RE: **Final**
Responses to United States Environmental Protection Agency (EPA) Comments Dated
November 9, 2007 on Quality Assurance Project Plan (QAPP) Addendum No. 4 for Interim
Measures at Solid Waste Management Unit (SWMU) 9 (Pesticide Control / R-150 Area)

**RESPONSE TO USEPA COMMENTS DATED NOVEMBER 9, 2007 (E-MAIL) ON
DRAFT QAPP ADDENDUM NO. 4
FOR SWMU 9 – PESTICIDE CONTROL AREA**

**RESPONSE TO USEPA COMMENTS DATED NOVEMBER 9 AND 11, 2007
RESOURCE CONSERVATION AND RECOVERY ACT (RCRA) ADDENDUM NO. 4
TO THE QUALITY ASSURANCE PROJECT PLAN (QAPP)
FOR SWMUS 8, 15, 18, 19, 20 AND THE OLD GUN TUB STORAGE LOT
FOR INTERIM MEASURES AT SWMU 7 (OLD RIFLE RANGE), SWMU 8 (BUILDING 106
POND), SWMU 13 (MINE FILL B), SWMU 17 (PCB BURIAL/POLE YARD), AND
SWMU 9 (PESTICIDE CONTROL AREA)
NSWC CRANE
CRANE, INDIANA**

REVISED FIGURE 3-1

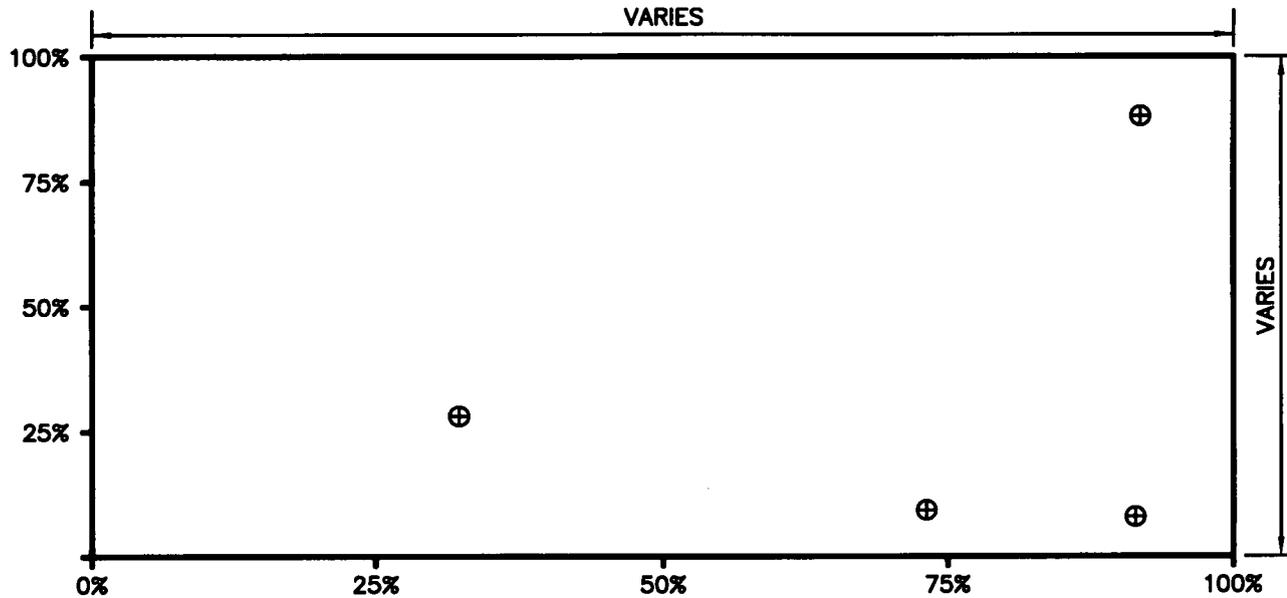
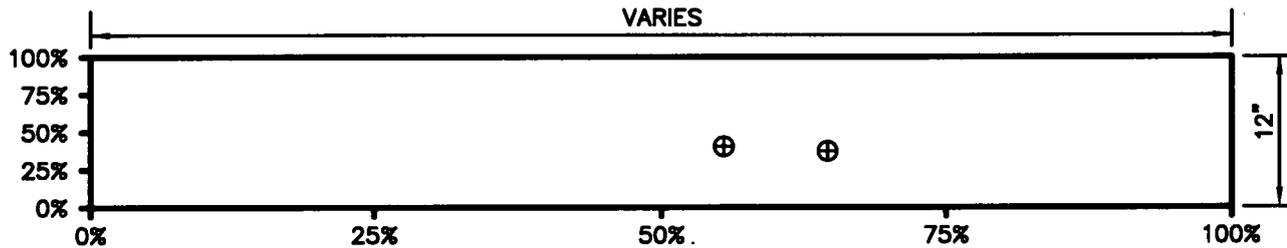
EPA-16(11-09-07). Figure 3-1 seems to have some mistakes. Should the references be instead to Table 3-3 instead of Table 3-6? And the points shown graphically don't seem to match the points in table 3-6.

Response to EPA-16(11-09-07): Agreed. Figure 3-1 has been revised to be consistent with Table 3-6. The revised Figure 3-1 is provided as Attachment 2 to this comment response document.
